DESCRIPTION **Ltr notarized 5-21-76 requests for
amdt to Tech Specs & trans the following:**

ENCLOSURE **Proposed changes to DAEC Tech Specs..**

PLANT NAME: Duane Arnold Plant

PROPOSED CHANGE RTS-66A TO DAEC TECHNICAL SPECIFICATIONS

Figure 3.6-1 Change in Charpy V Transition Temperature Versus Neutron Exposure

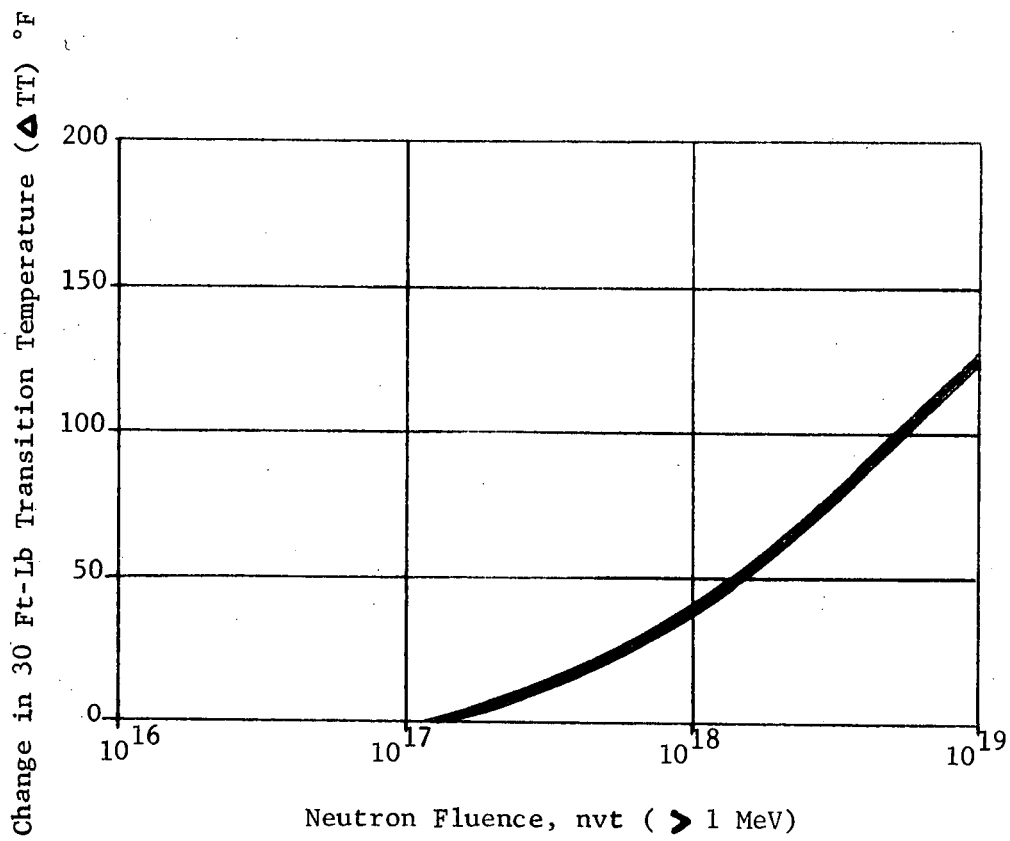
Delete the present Specification 3.6.A and 4.6.A (Limiting Conditions for Operations, Surveillance Requirements and Bases for Thermal and Pressurization Limitations) including Table 3.6-1 and Figure 3.6-1.

Replace with the attached Specification 3.6.A and 4.6.A, including Figures 3.6-1, 3.6-2A, 3.6-2B and 3.6-2C.

General Electric recommendations for making this periodic adjustment include the application of the shift curve, Figure 2, from NEDO-10115 (Figure 3.6-1 of the proposed Technical Specifications), Upper Limit for 550°F GE BWR Operating Experience. Until the estimated neutron fluence at the 1/4 thickness points discussed above reaches 3×10^{17} , there should be no need to make any adjustments to the beltline operating limit curves.

A relationship between neutron fluence and change in Charpy V, 30 foot pound transition temperature has been developed for SA302B/SA533 steel based on at least 35 experimental data points as shown in Figure 3.6-1. In turn, this change in transition temperature can be related to a change in the temperature ordinate shown in Figure G 2110-1 in Appendix G of Section III of the Boiler Code.

Figure 3.6-2A Minimum Temperature for Pressure Tests

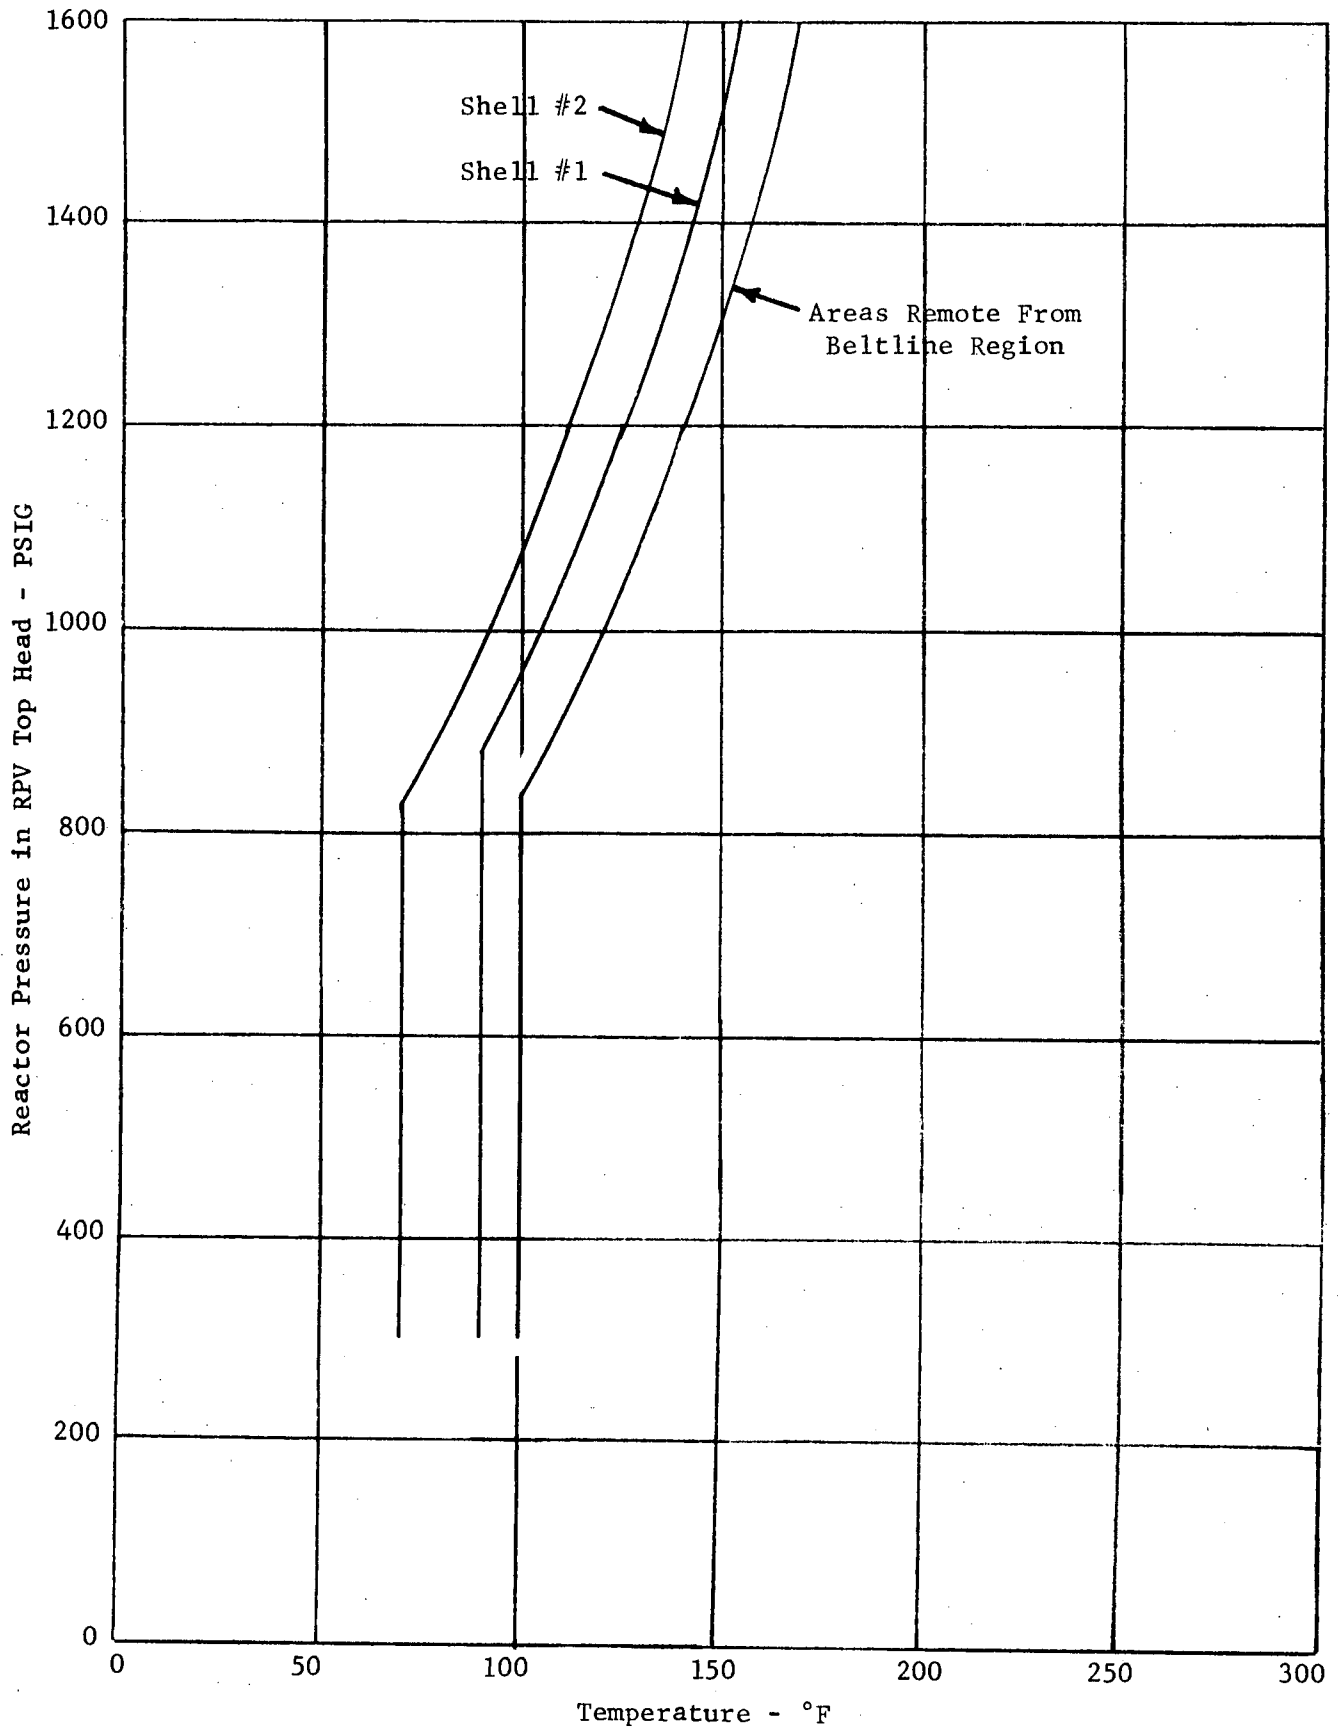
Operating limits on RPV pressure and temperature during normal heatup and cooldown, and during inservice hydrostatic testing, were established using Appendix G to the ASME Boiler and Pressure Vessel Code, Section III, 1971 (Appendix G was first added in the Summer 1972 Addenda) as a guide (see Figures 3.6-2A, B and C of the proposed Technical Specifications). These operating limits will ensure that a large postulated surface flaw, having a depth of one-quarter of the material thickness, can be safely accommodated in regions of the RPV shell remote from discontinuities.

2. The reactor vessel shell temperatures during inservice hydrostatic or leak testing shall be at or above the highest of the temperatures shown on the curves of Figure 3.6.2A where the RPV shell beltline region curves are increased by the expected shift in RT_{NDT} from Figure 3.6-1.

Figure 3.6-2C Minimum Temperature for Criticality

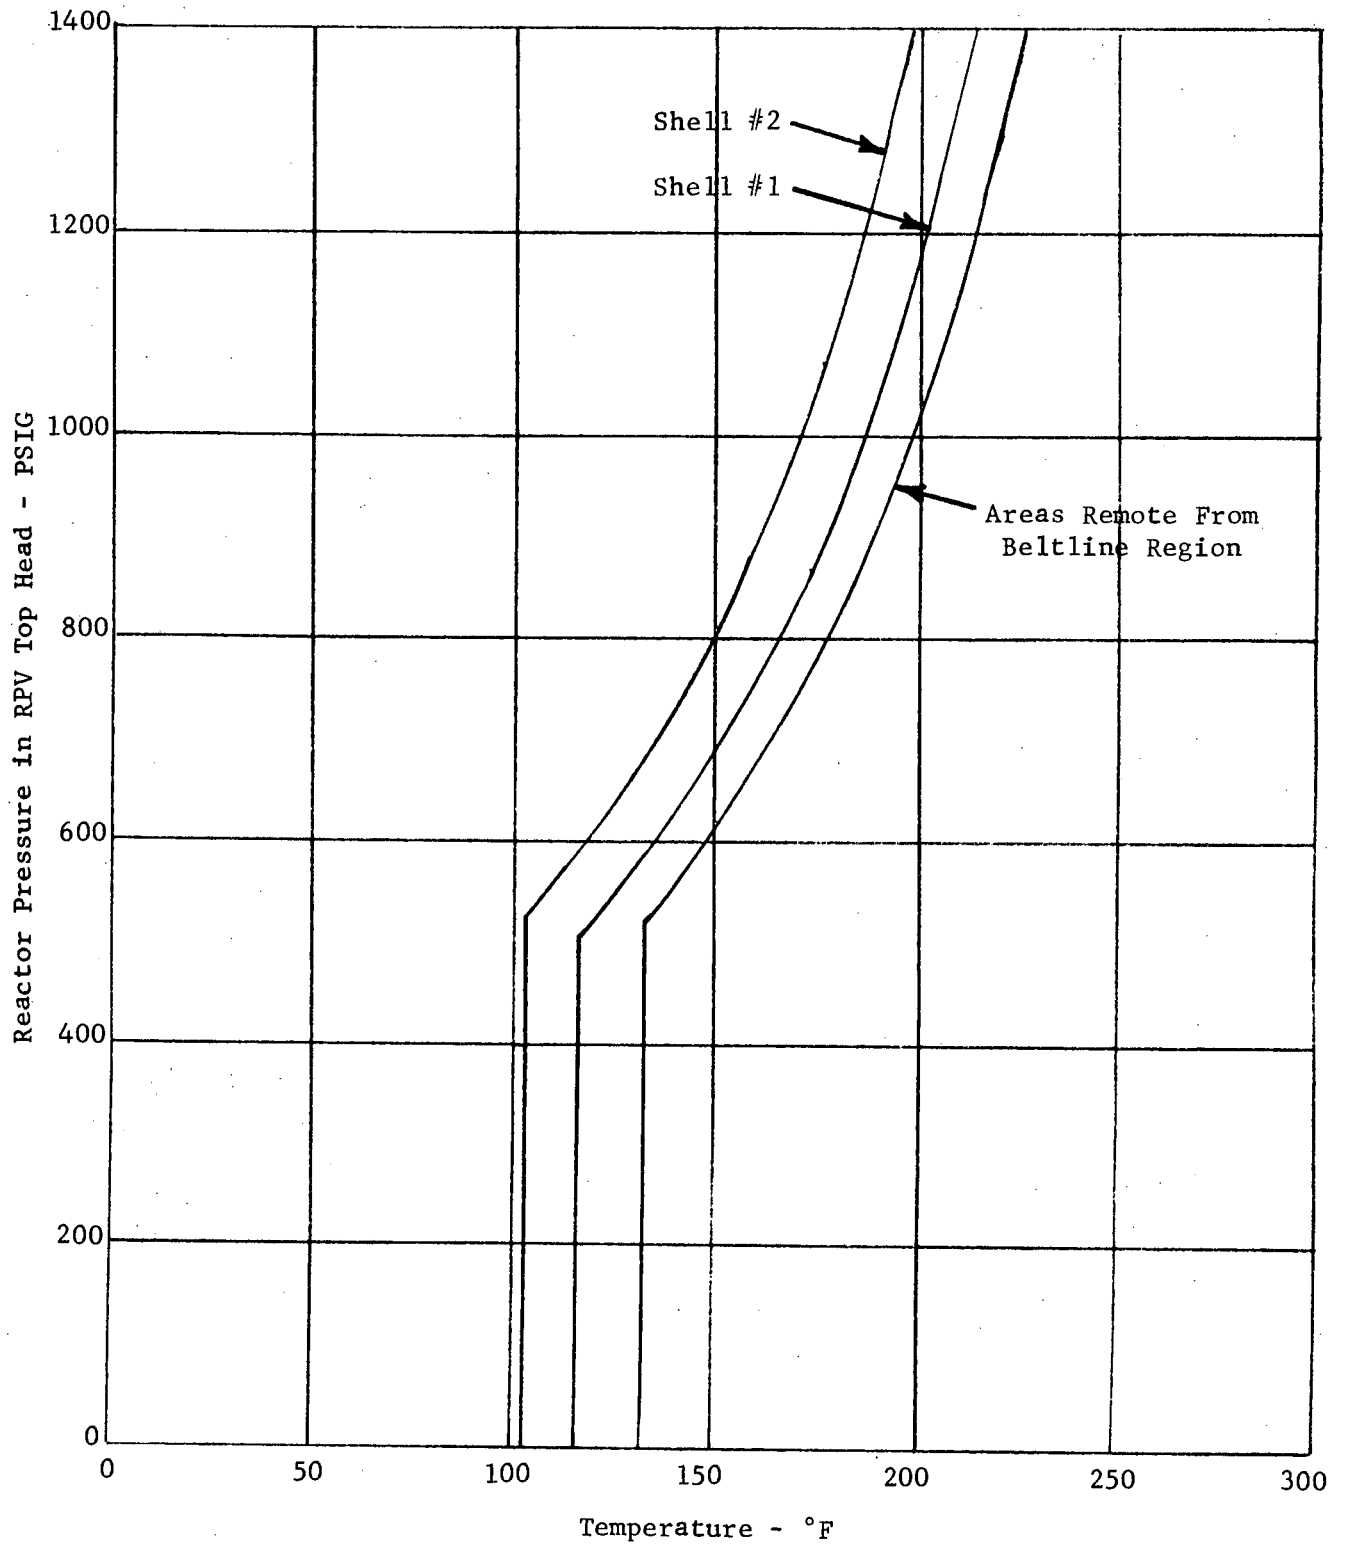
core operation show by vertical lines that no core operation is permitted below the minimum temperature for an 1100 psig ISI hydrostatic test. The enclosed proposed Technical Specifications illustrate the use of the operating limits.

During all operation with a critical core, other than for low level physics tests, the reactor vessel shell and fluid temperatures of 4.6.A.1 shall be at or above the highest of the temperatures of Figure 3.6-2C where the RPV beltline curves are increased by the expected shift in RT_{NDT} from Figure 3.6-1.
